Flight Procedures Cover Page	Task Action: FLIGHT CHECK	Task Type: IAP	Estimated Chart Date: 08/07/2025	APWS Task ID: 878939AD61994EBA86E890E204B15CD5	APWS Project ID: 1680B6486CE84581AA1C1C3C417A9B26
Procedure: RNAV (GPS) RWY 30 ORIG		Enroute: NO	Specialist: Keefer, John		Agreement Number:
Airport ID: S64			Airport City: STANFORD		State: MT
Facility ID:	Facility Type:	Flight Inspection Remark Type: New FC Slot			
<div>Procedure Comments: PENDING DATA USED.</div> <div>AIRPORT MAGVAR CHANGE FROM E16 1985 TO E11 2025.</div> <div>VFR TO IFR.</div> <div>AIRSPACE DOCKET #24-ANM-108.</div> <div>CONTACT CASIMIR TABAKA 405-954-7931.</div> <div>4/1/2025: THIS IS AN UPDATED COPY OF THE FORMS DEVELOPED ON 12/17/2024. RAISE CAT C CIRCLING MDA TO 5600 PER FLIGHT INSPECTION. NEW MDA/VIS/HAA 5600/3/1272.</div> <div>QUALITY 16 CHECKED</div> <div>QUALITY 41 CHECKED</div> <div>QUALITY 42 CHECKED</div>

FIPC BASIC FORM						
PROCEDURE: RNAV (GPS) RWY 30 ORIG			AIRPORT NAME: STANFORD/BIGGERSSTAFF FLD		AIRPORT ID: KS64	SPECIAL CONTROL NO: SG-02-150-25
FAC ID: KS6430		CITY: STANFORD			ST: MT	ORIG CHART DATE: 08/07/2025
DFL TYPE: PROC/S	THIRD PARTY: <input type="checkbox"/> YES	EST. TIME ON SITE: 0.4	REIM

S64
STANFORD/BIGGERSSTAFF FLD
STANFORD, MT
RNAV (GPS) RWY 30 ORIG
CIRCLING
1:100,000

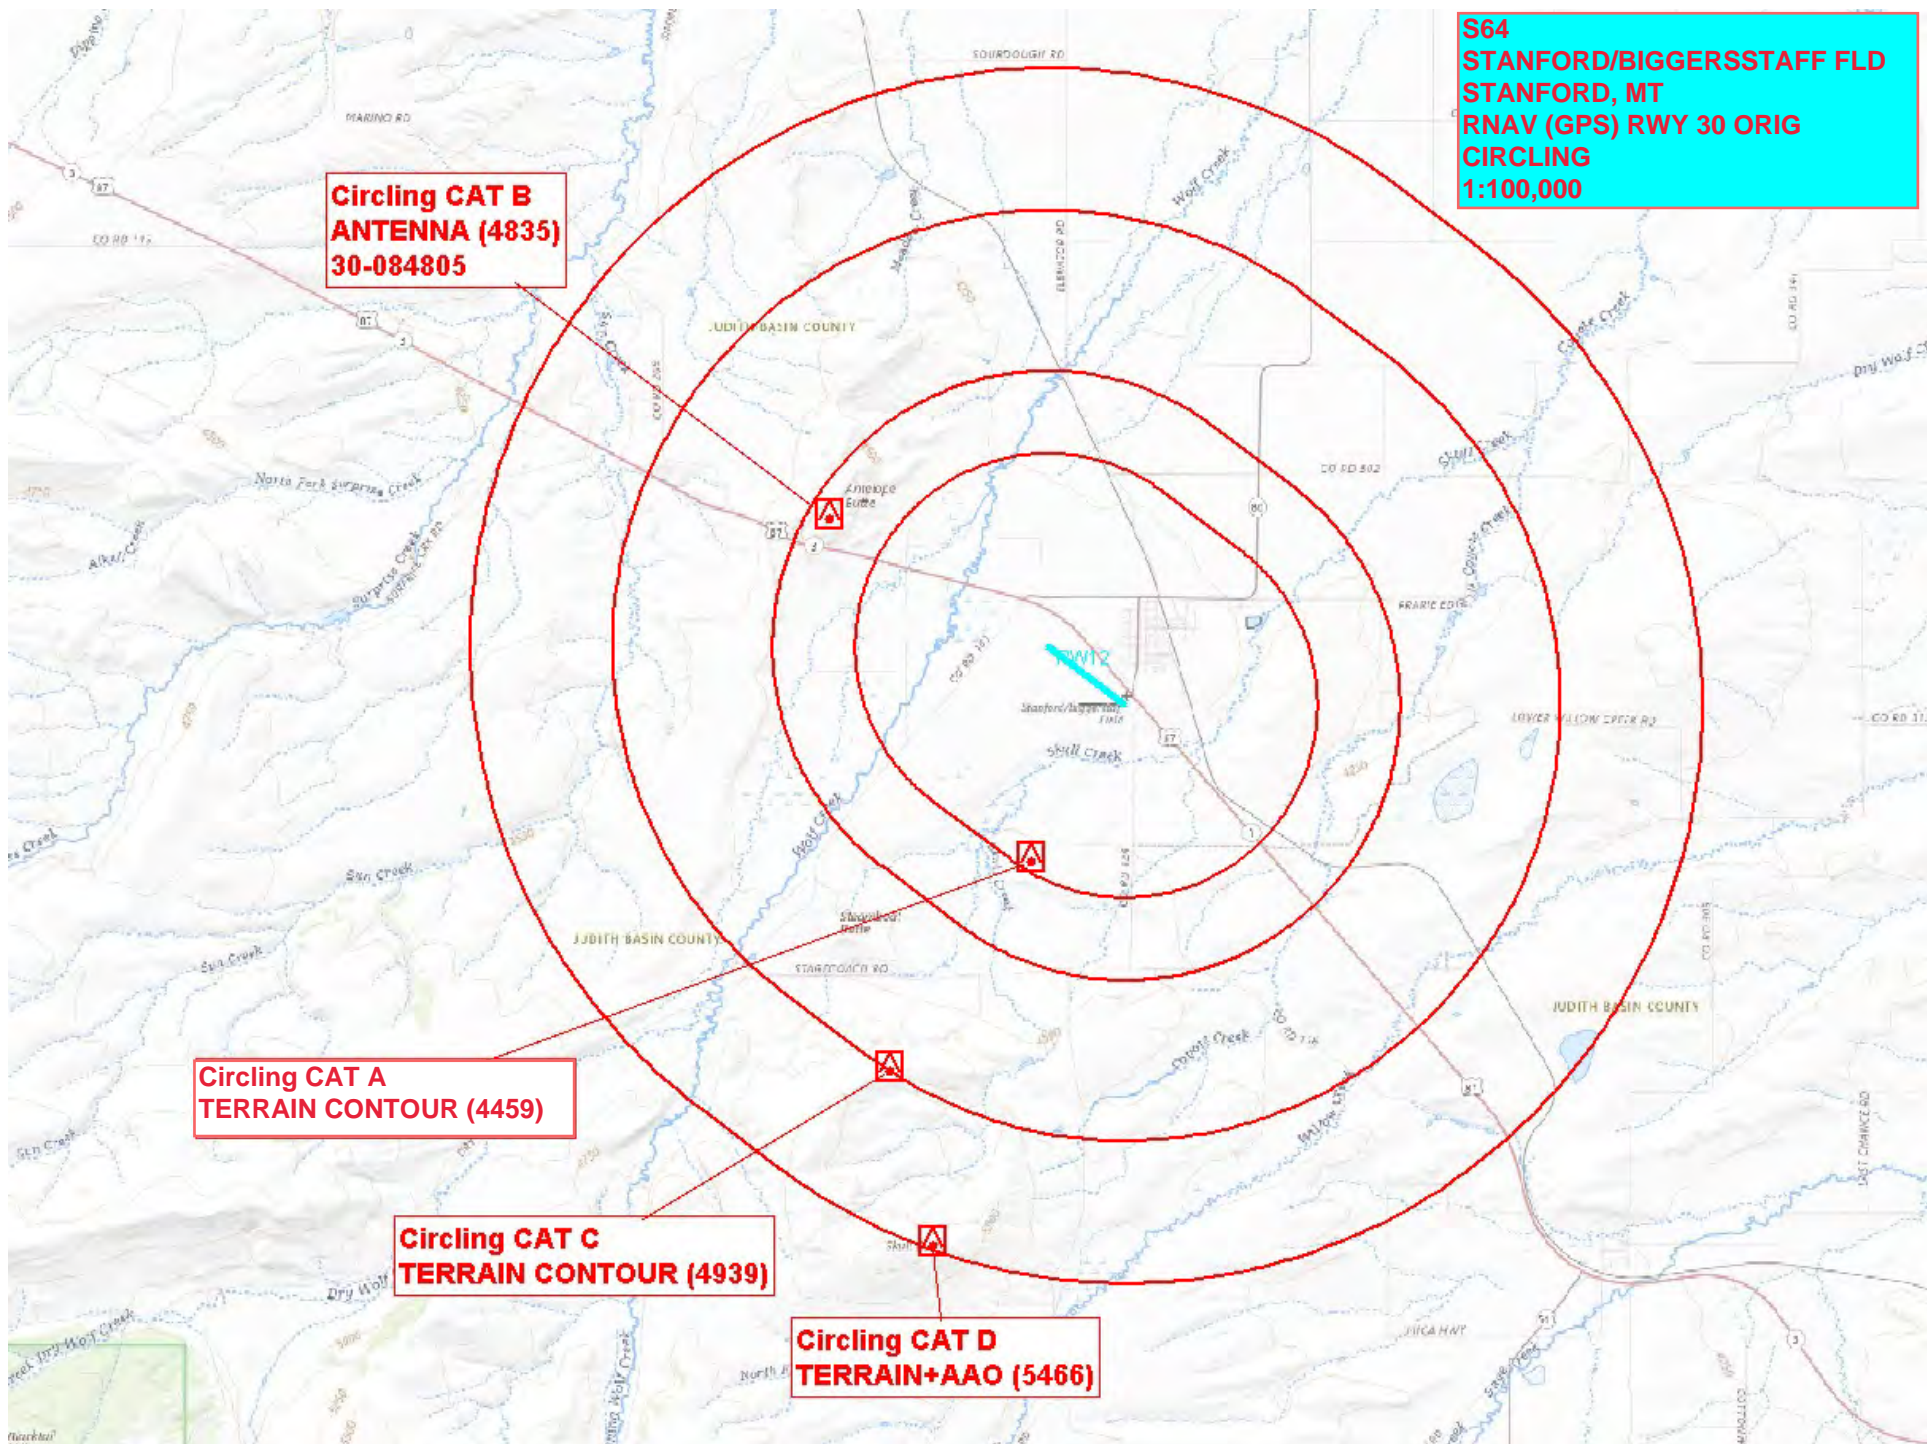
FLIGHT INSPECTOR SIGNATURE: wendi s gima @ 03/27/2025 22:28			PRINTED NAME: GIMA, WENDI SUEMI			NOTAM INITIATED? <input type="checkbox"/> YES <input checked="" type="checkbox"/> NO
FLIGHT INSPECTOR REMARKS: 3/13/25 N72 Incomplete due to turbulence and LLWS. Items flown satisfactory this date are as follows: 1) All feeders flown sat, 2) WABMI hldg sat, 3) Procedure Survey sat, 4) Missed App hldg at YOGOS sat, 5) Salt Lake CTR (ZLC) Freq 133.40 verified sat at required fixes, 6) LWT ASOS verified Sat at IAFs. 7) CAT A & B circling mins flown sat. ITEMS REMAINING - 1)FLY Initial portion of Missed approach from LPV minimums for obstacle evaluation, 2) FLY CAT C & D circling minimums. Obstacle clnce questionable (flyability). Recommend raising CAT C circling mins to 5600' STANDFORD/BIGGERSTAFF FLD (S64) STANFORD, MONTANA, RNAV (GPS) RWY 30 Commission, SAT w/Changes*. This inspection was begun by N72 on 3/13/25. Today we completed items left: 1) flew the initial portion of Missed approach from LPV minimums for obstacle evaluation-SAT. 2) Fly CAT C & D circling mins, CAT D-SAT, CAT C-UNSAT. *Change required: Raise CAT C minimums to 5600' to provide adequate obstacle clearance. Periodic requirements met.
